Pentium® Pro Processor Specification Update

Release Date: December 1997

Order Number: 242689-023

Figure 4-3. Stack Switch on a Call to a Different Privilege Level

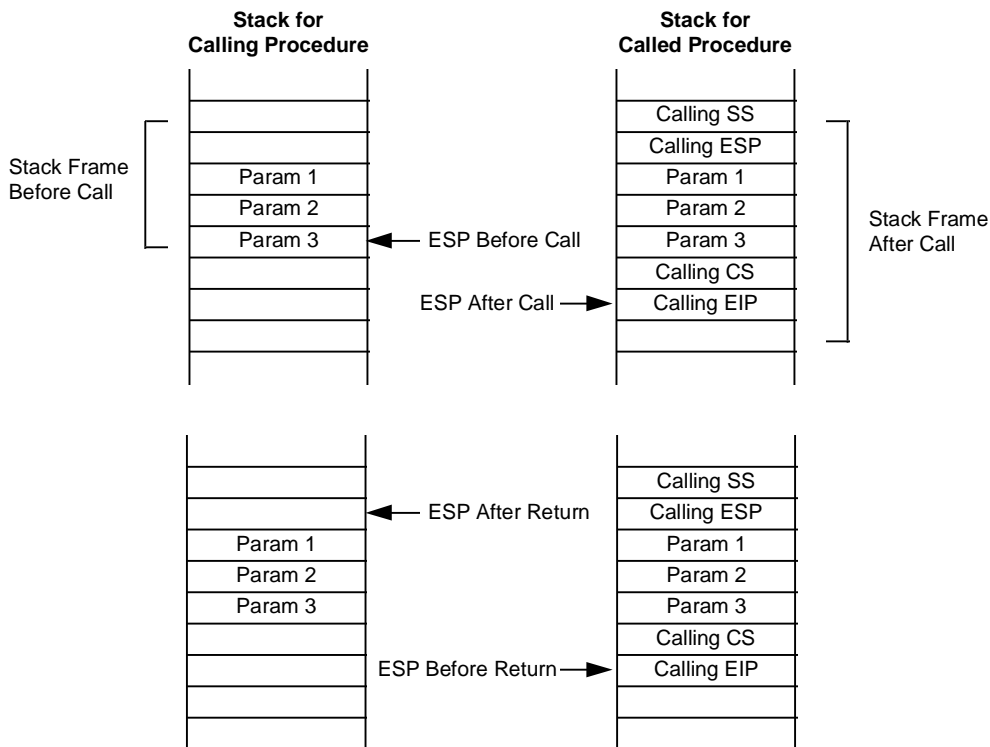
4.3.6. CALL and RET Operation Between Privilege Levels

When making a call to a more privileged protection level, the processor does the following (see Figure 4-3):

1. Performs an access rights check (privilege check).
2. Temporarily saves (internally) the current contents of the SS, ESP, CS, and EIP registers.
3. Loads the segment selector and stack pointer for the new stack (that is, the stack for the privilege level being called) from the TSS into the SS and ESP registers and switches to the new stack.

4. Pushes the temporarily saved SS and ESP values for the calling procedure's stack onto the new stack.
5. Copies the parameters from the calling procedure's stack to the new stack. (A value in the call gate descriptor determines how many parameters to copy to the new stack.)

3. (If the RET instruction has an optional *n* argument.) Increments the stack pointer by the number of bytes specified with the *n* operand to release parameters from the stack. If the call gate descriptor specifies that one or more parameters be copied from one stack to the other, a RET *n* instruction must be used to release the parameters from both stacks. Here, the *n* operand specifies the number of bytes occupied on each stack by the parameters. On a return, the processor increments ESP by *n* for each stack to step over (effectively remove) these parameters from the stacks.

4. Restores the SS and ESP registers to their values prior to the call, which causes a switch back to the stack of the calling procedure.
5. (If the RET instruction has an optional *n* argument.) Increments the stack pointer by the number of bytes specified with the *n* operand to release parameters from the stack (see explanation in step 3).

Figure 4-4. Stack Usage on Transfers to Interrupt and Exception Handling Routines

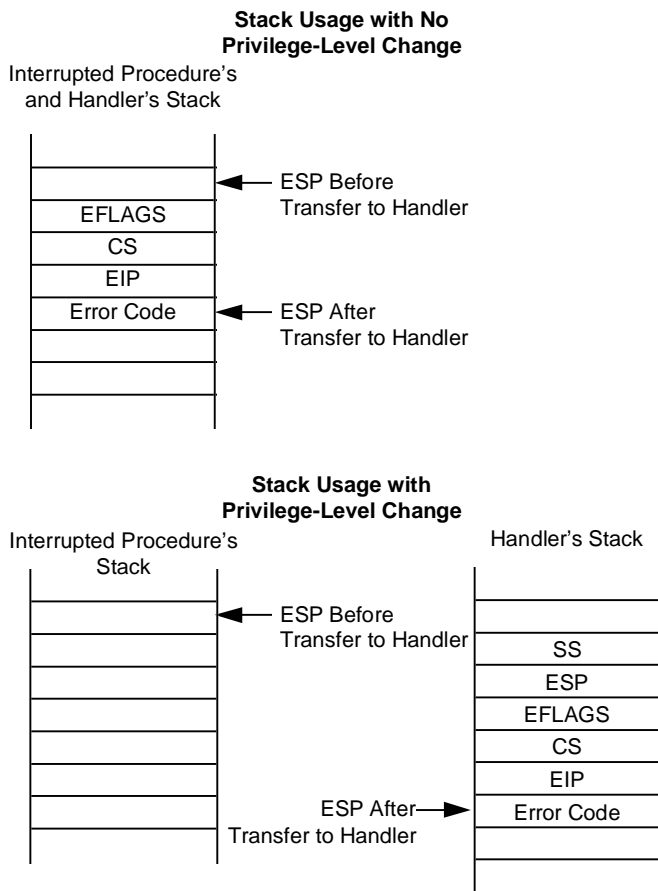
If no stack switch occurs, the processor does the following when calling an interrupt or exception handler (see Figure 44):

When executing a return from an interrupt or exception handler from a different privilege level than the interrupted procedure, the processor performs these actions:

1. Performs a privilege check.
2. Restores the CS and EIP registers to their values prior to the interrupt or exception.
3. Restores the EFLAGS register.
4. Restores the SS and ESP registers to their values prior to the interrupt or exception, resulting in a stack switch back to the stack of the interrupted procedure.
5. Resumes execution of the interrupted procedure.
